Kind : LBA Airworthiness Directive AD-Note No. 78 - 303

Subject : Safety measures for inspection hole cover in fuselage.

Effectivity : All ASW 19s, serial numbers 19 001 through 19 232.

Schnitt A-B
Section A-B

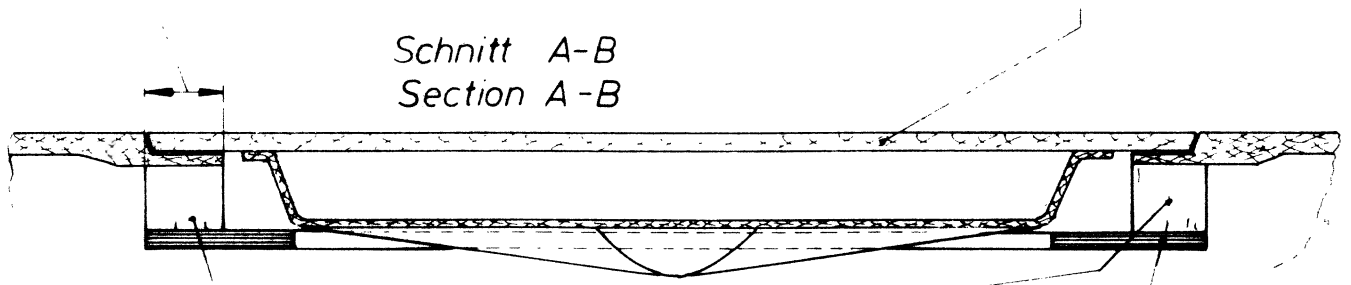
Instructions : TN 7a :
By means of a plywood ring (P/N 190.11.0125) the hole of which is narrower than the smallest width of the inspection hole cover it is prevented that the cover can get into the fuselage.
Prior to glueing in the plywood ring the glue joints must be well fitted and sanded.
A mixture of
100 parts in weight of Epikote 162
38 parts in weight of Epikure 113,
thickened by 10 - 15 parts in weight of Aerosil,
may be used as a glue. However, it may be as well used Aerodux or a two-component glue (like UHU-plus).

For the cover itself or the bungee no modification is necessary. See the drawing on sheet 4 of this TN.

After the installation the plywood ring and the sanded areas around it are preserved by paint or epoxy resin.

diesen Bereich vor dem
verkleben aufrauen

Sand this area prior to glueing

bei Montage anpassen
Adjust for assembly

Lochblende
Shield
